Town of Ramapo
Building, Planning and Zoning Department

COMMUNITY DESIGN REVIEW COMMITTEE
April 23, 2025

2023.037: 1507 Route 202 Site Development Permit
1507 Route 202, Pomona
Tax Lot: 33.05-2-15
Zoning: PO
Use: Professional Office
Project update

From: Joel Bianchi, PE, Principal / Senior Vice President of Civil Engineering
Dennis Lynch, PE, Project Manager
Aneisha Samuels, Planning Consultant
MJ Engineering & Land Surveying PC

SITE PLAN
FOR
1507 ROUTE 202
TOWN OF RAMAPO - ROCKLAND COUNTY - NEW YORK

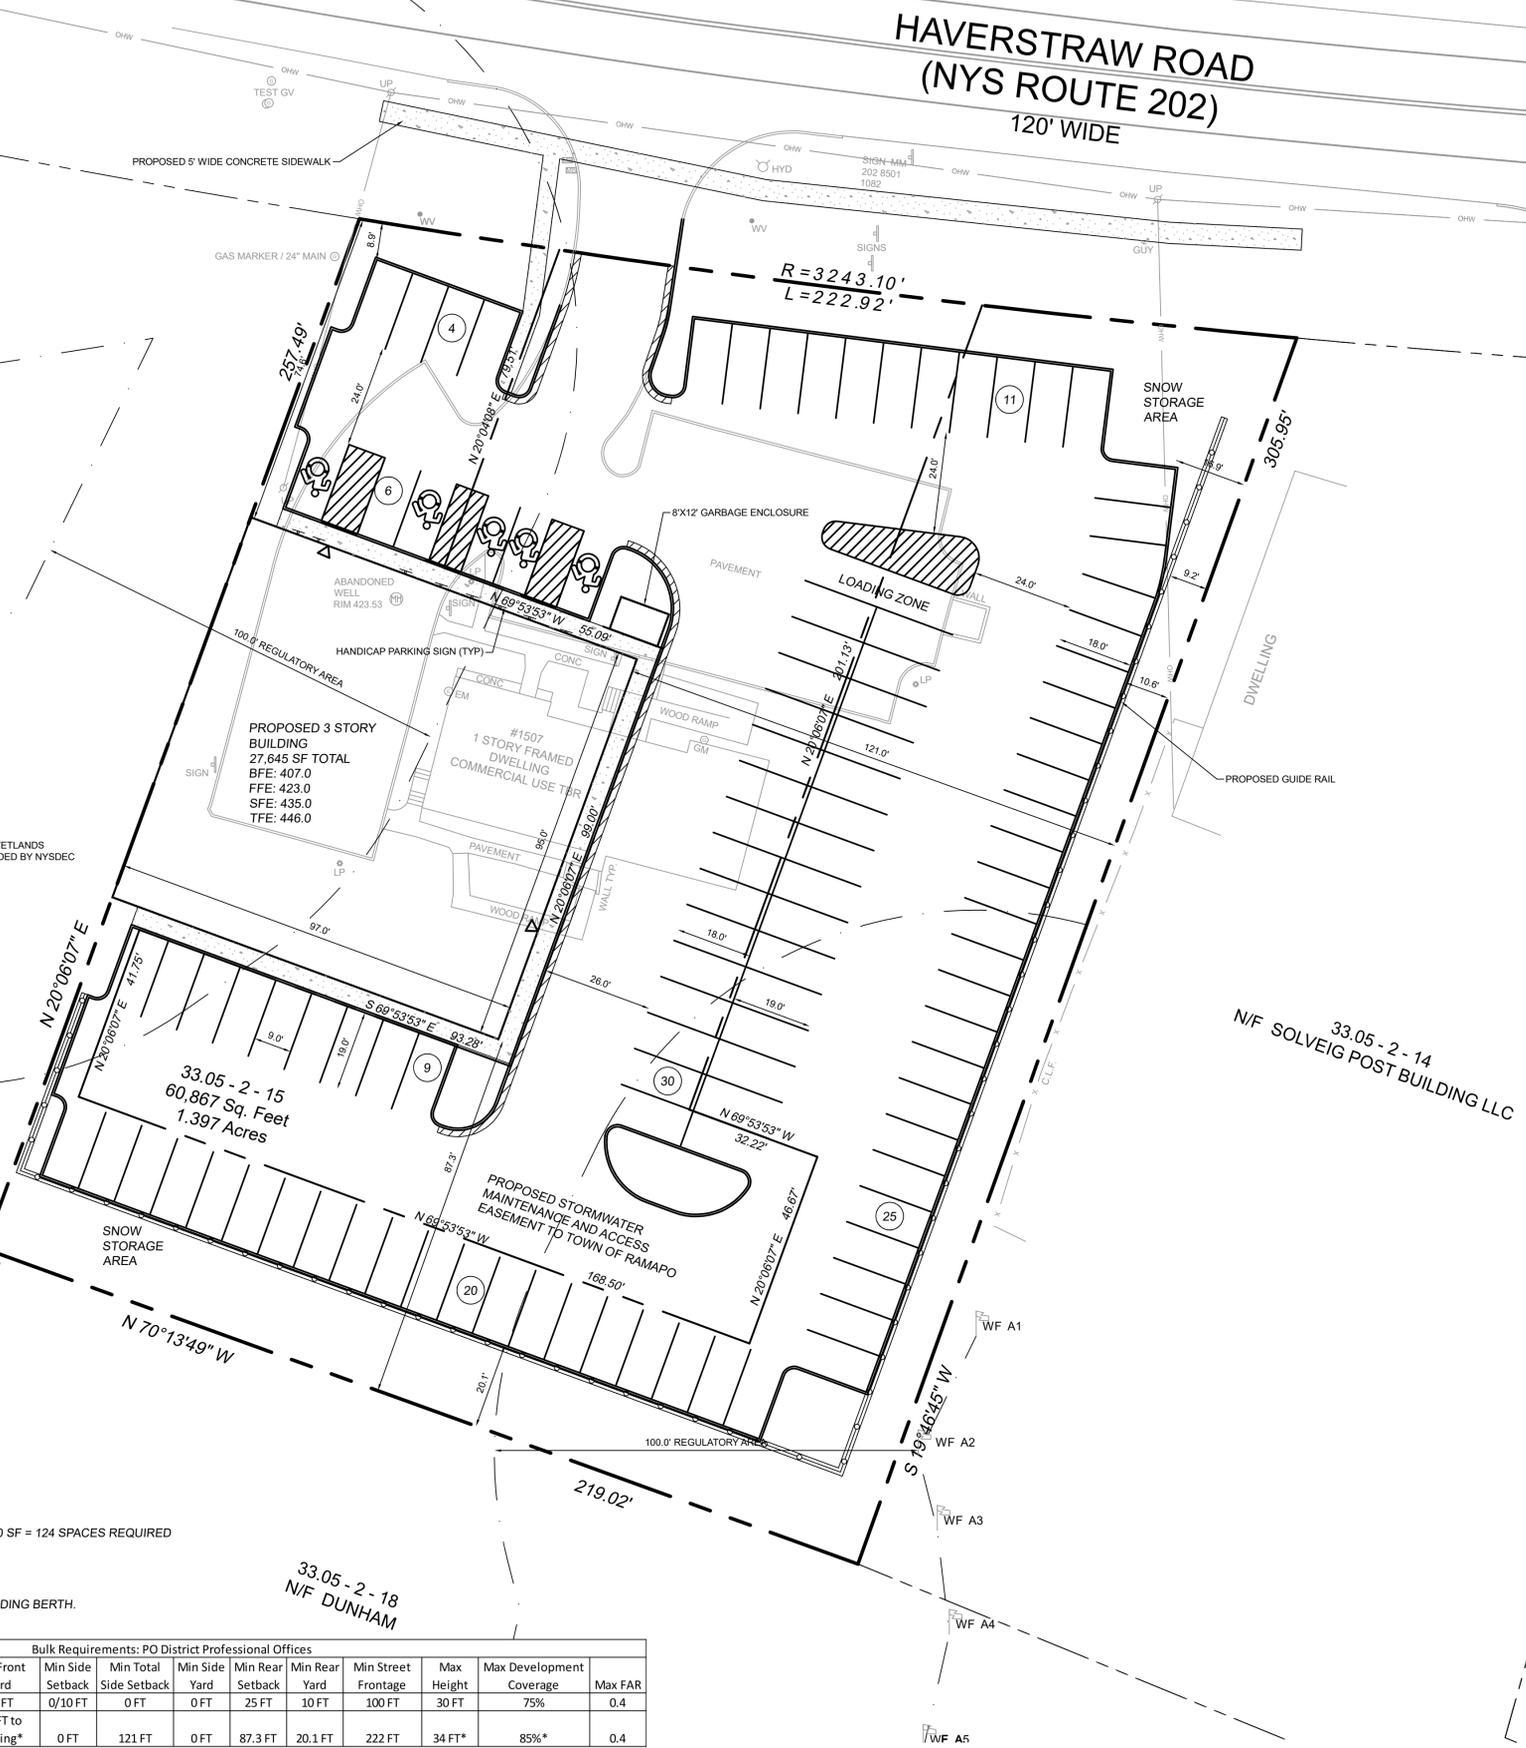
11. As noted in Comment 11 of our March 5, 2024 review, update Note 29 if and when the requested variances are granted.

12. As noted in Comment 12 of our March 5, 2024 review, if and when approved, provide the XBA number for the variances being requested.
13. As noted in Comment 15 of our March 5, 2024 review, the development proposed work within the NYSDEC wetland 100-foot adjacent area. The applicant shall provide the Town with a copy of the adjacent area permit once received, which shall be prior to receipt of final signed plans.

14. As noted in Comment 18 of our March 5, 2024 review, identify the location for the required ADA accessible route from the accessible aisle to the accessible entrance(s) of the building.

15. As noted in Comment 14 of our December 3, 2024 review, the plans indicate designated snow storage on the southern side of the site. However, alternative areas should be considered because the proposed retaining wall and fence will prevent snow from being stored in this location. If snow needs to be removed from the site, please include a note specifying this requirement, along with the maximum timeframe for its removal.

16. The plans note the total square footage of the buildings as 27,645 square feet; however, the parking calculations note 24,722 square feet. The plans and the parking calculations shall be revised to be consistent.

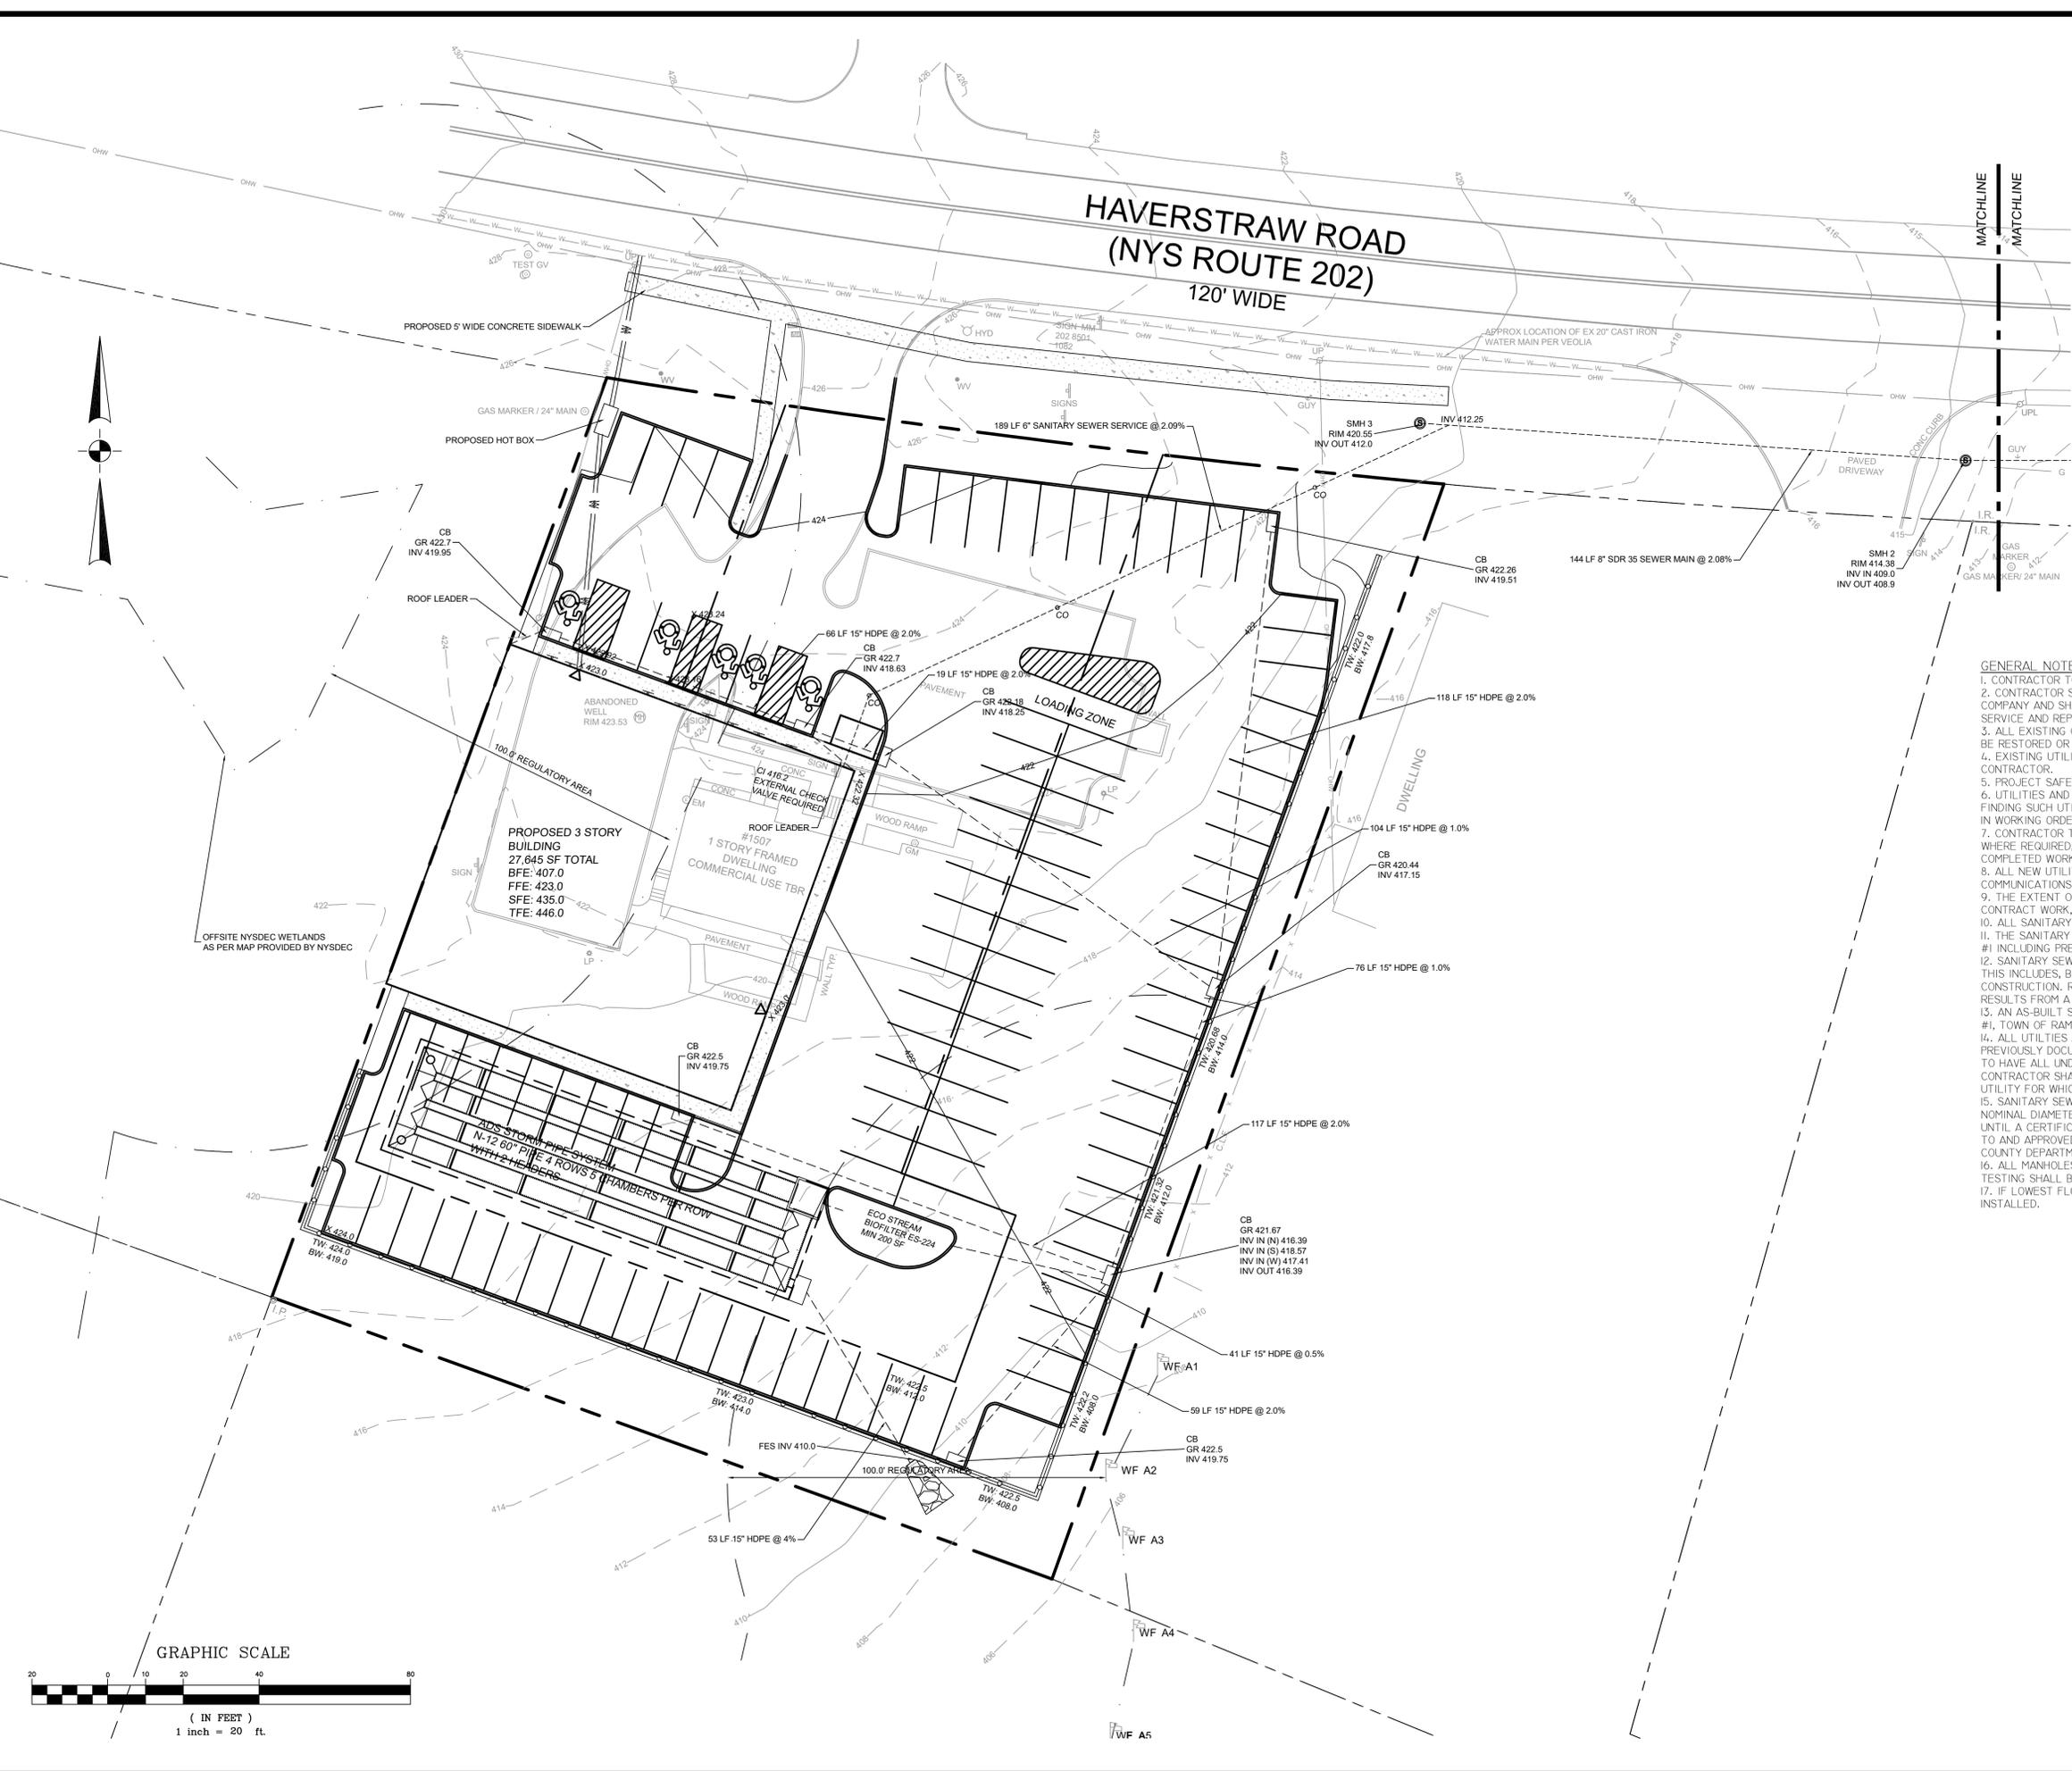
17. All sanitary sewer improvements shown, which appear to include an individual service lateral and sewer main extension, are subject to the review and approval by the Town of Ramapo DPW, Rockland County Department of Health, and/or Rockland County Sewer District No. 1. Any required revisions to the sanitary sewer system design shall be provided on subsequent plan submissions.
18. All water system improvements shown, which appear to include an individual service lateral, are subject to review and approval by Veolia Water. Any required revisions to the water system design shall be provided in subsequent plan submissions.

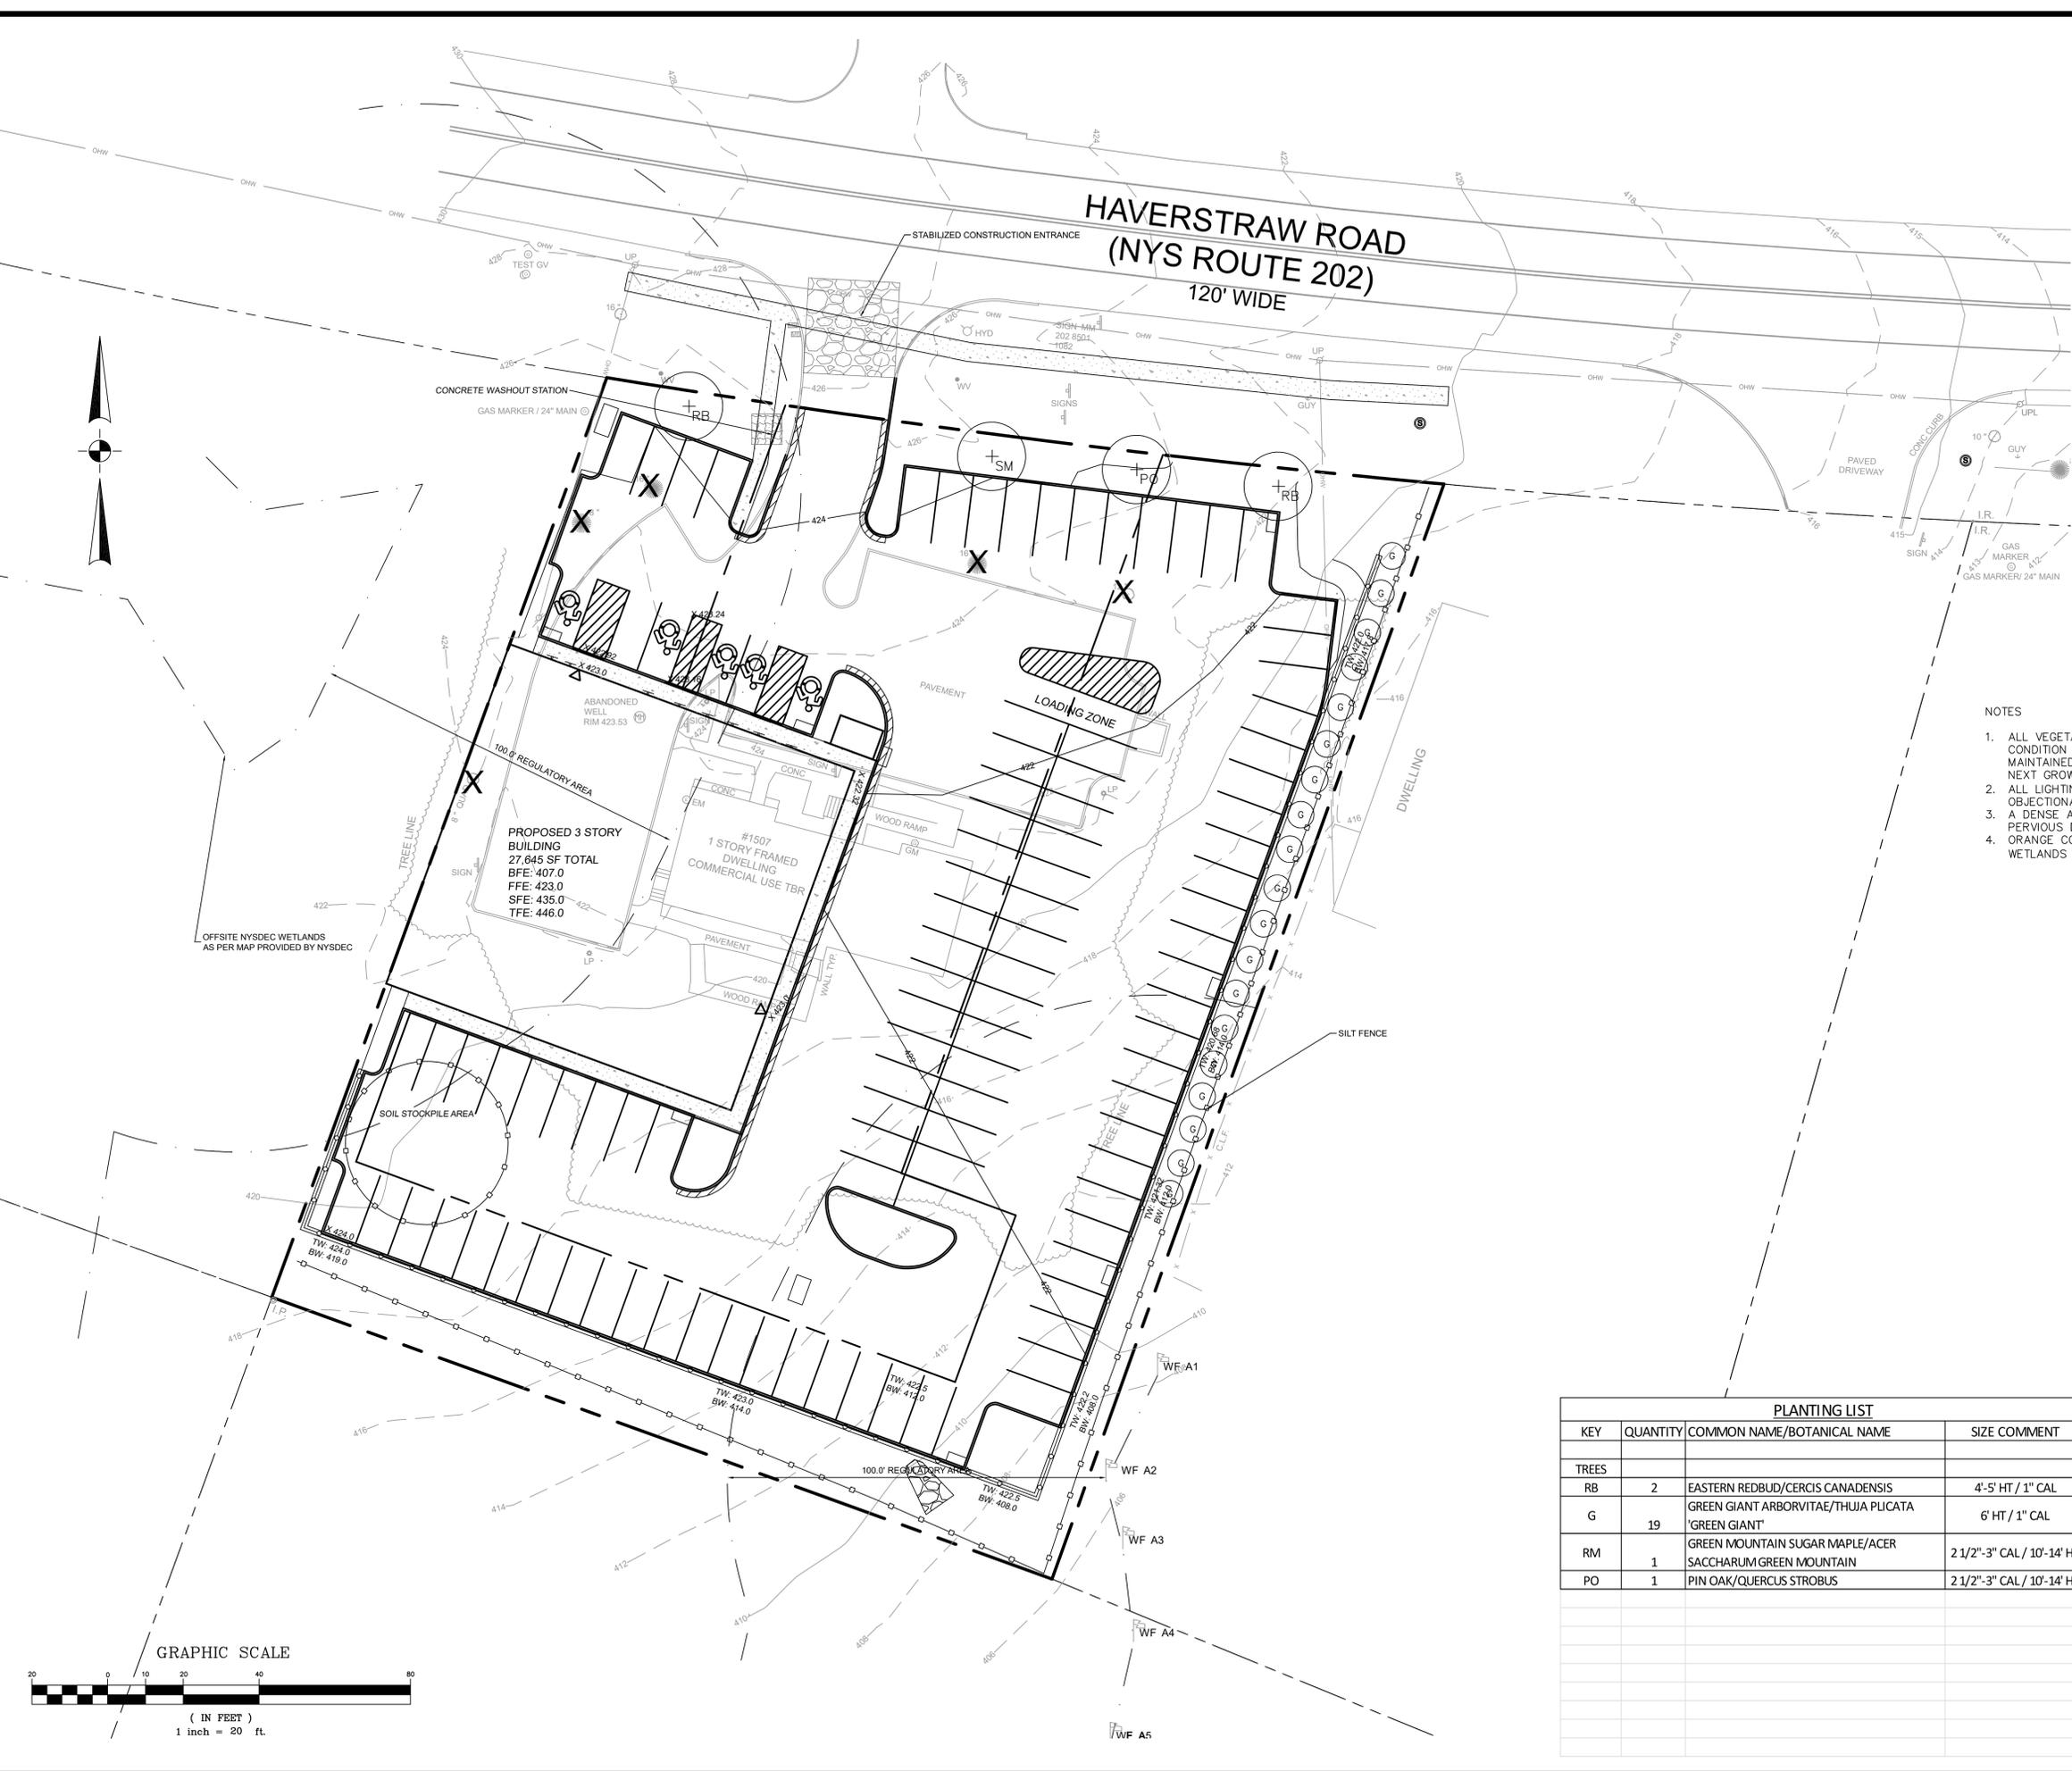
21. As noted in Comment 19 of our December 3, 2024 review, the applicant should consider adding a landscape island in the striped area to the north of the loading zone. This addition will also help reduce the maximum development coverage variance being requested.
